Tweed Sand Plant

Flood & Stormwater Assessment

Client: Hanson Construction Materials

Document No: BE190043-RP-FSA-07

Figure 3.1 Conceptual Stormwater Management Schematic

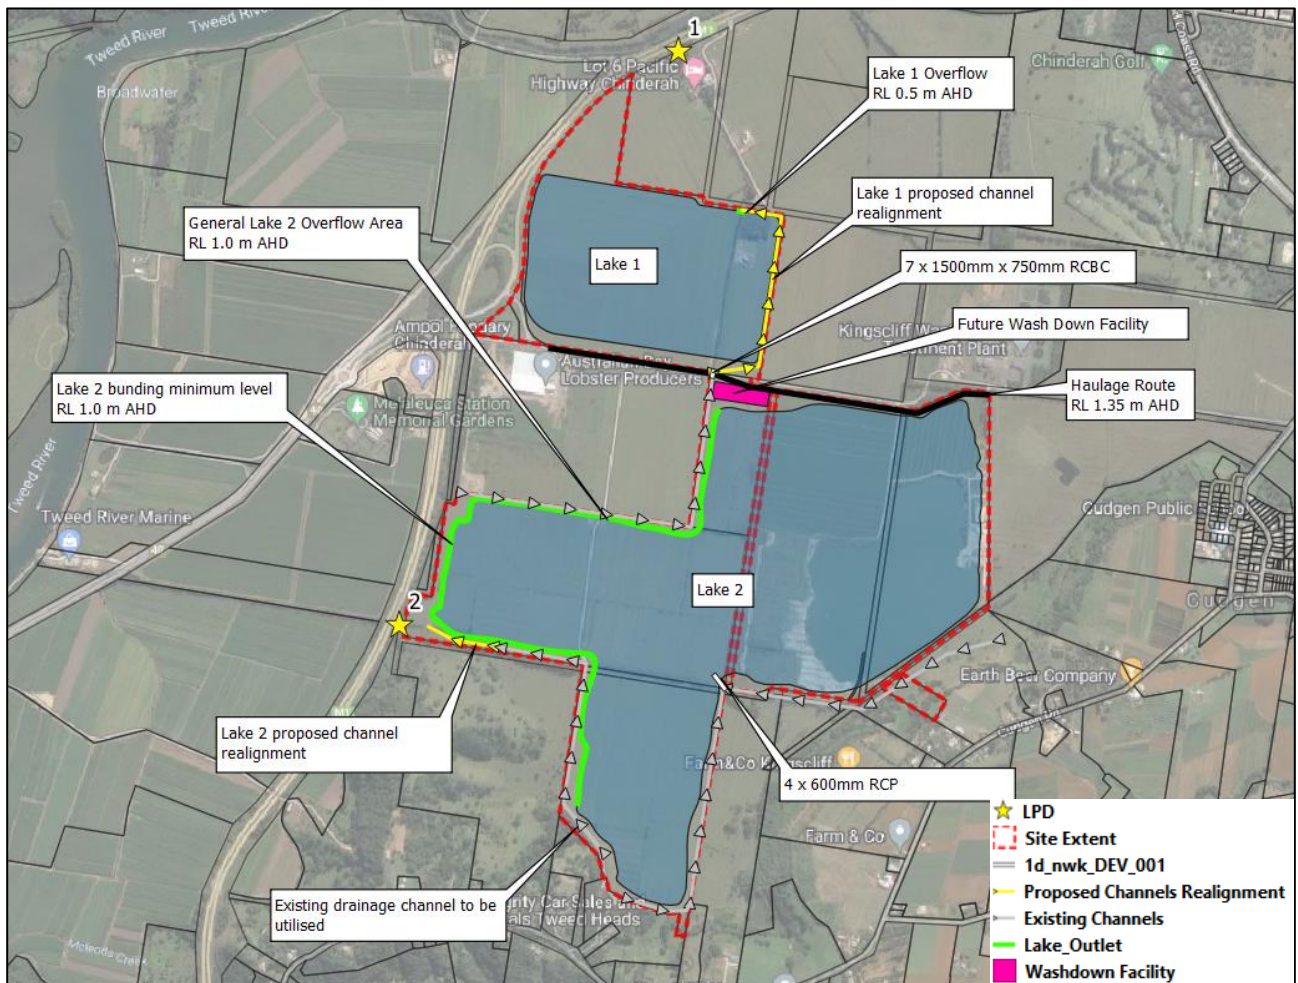
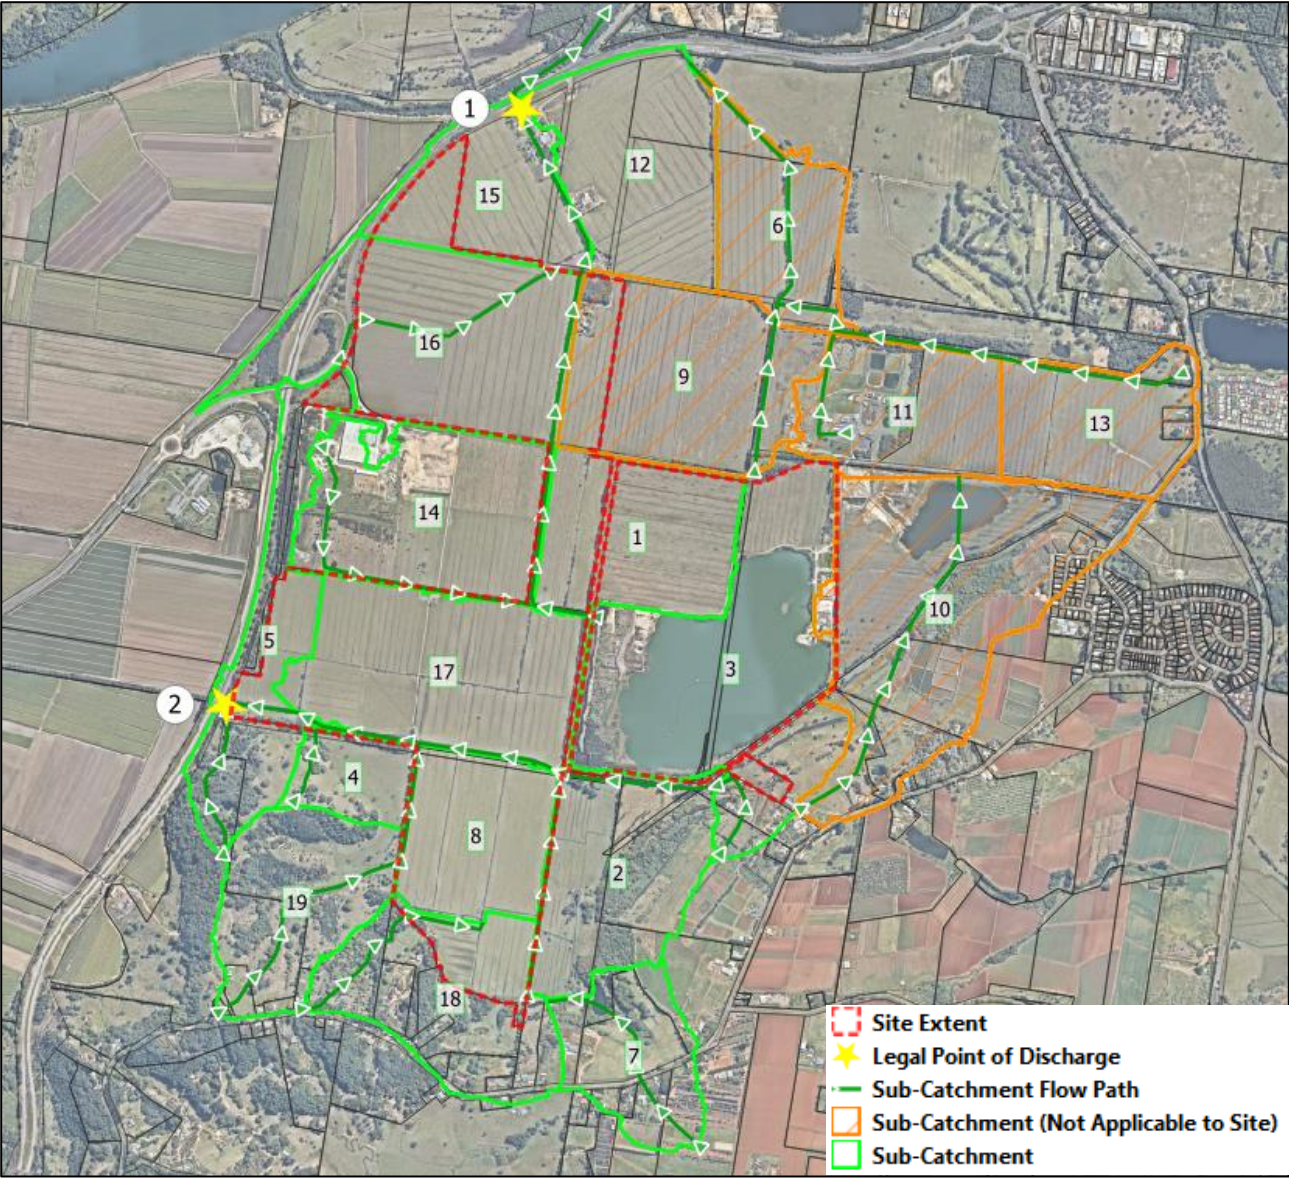
Information Request	Request Response
B. Stormwater / Agricultural System	
We believe that the depiction of the stormwater and agricultural drainage system within the EIS and supporting Flood & Stormwater Report (Burchills, 2021) is erroneous. Specifically on Figures 3.2 and 3.3 of	Catchment Mapping provided in Figure 3.2 and Figure 3.3 is indicative for the immediate local catchments and does not

Figure 4.5 Cumulative Development Scenario

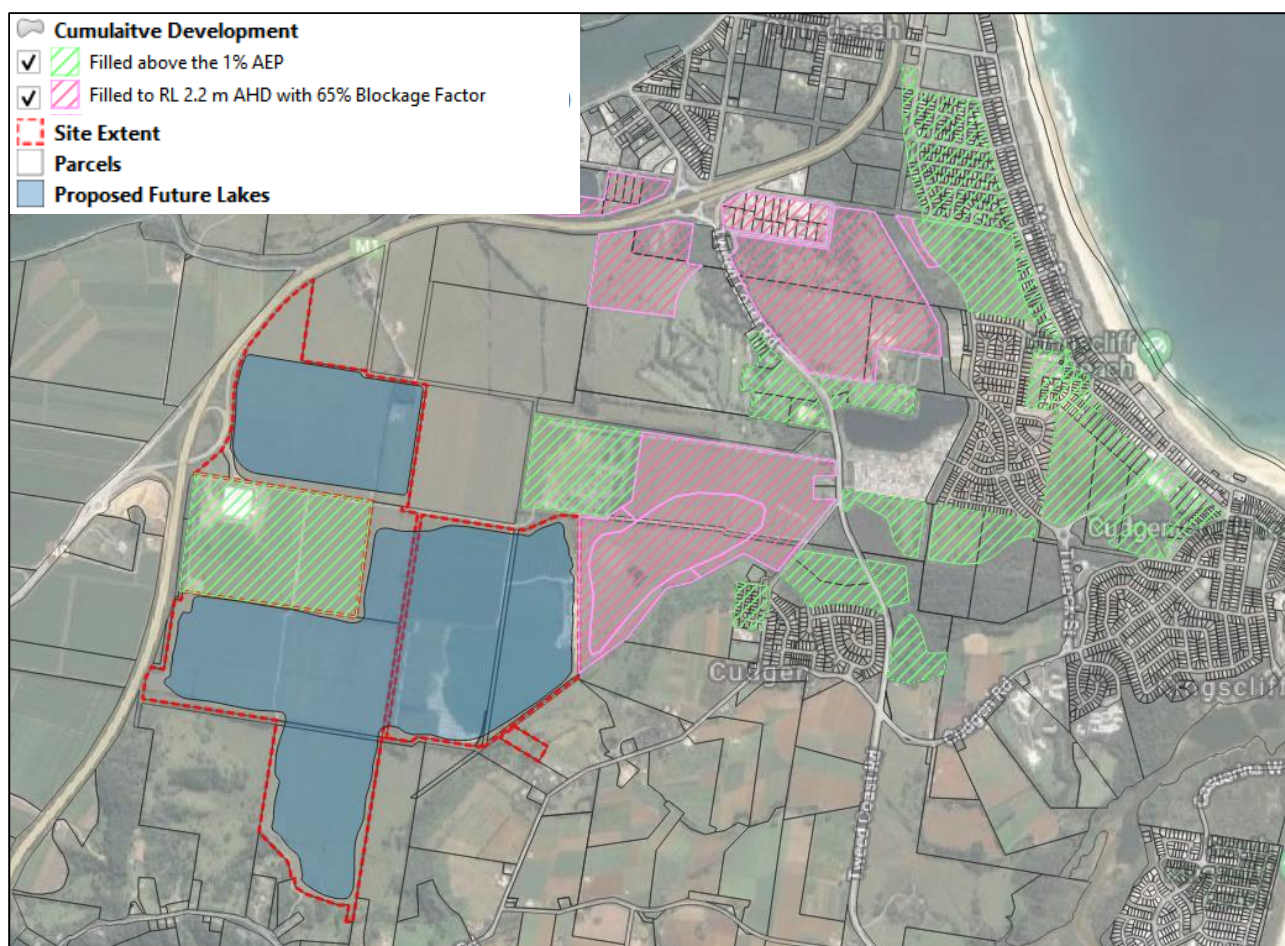
1.4 Cumulative Development Scenario A Cumulative Development Scenario is now included in the proponent's revised FSA. It has adopted Council's TVFRMS&P 2014 fill / development scenario combined with the proposed lakes. It is noted that no consultation was undertaken with Council, as suggested, to incorporate any changes since 2014. It appears that the proponent may have misunderstood the configuration of the Cumulative Development scenario. The FSA notes that: "Industrial development in Chinderah (filled to 2.2m AHD, to represent 65% site coverage for flow obstructions above 2.2m AHD)". It is unclear whether this is a typo, but it appears that the FSA only included fill to 2.2m AHD in these areas. It should be fill to 2.2m AHD WITH 65% site coverage (blockage) above this level. If this has not been applied to the model correctly this may significantly influence the results. Further information is required in this regard.	The cumulative development scenario assessment has been updated in consultation with Council. Representation of cumulative development now 65% blockage for all area above RL 2.2m AHD.
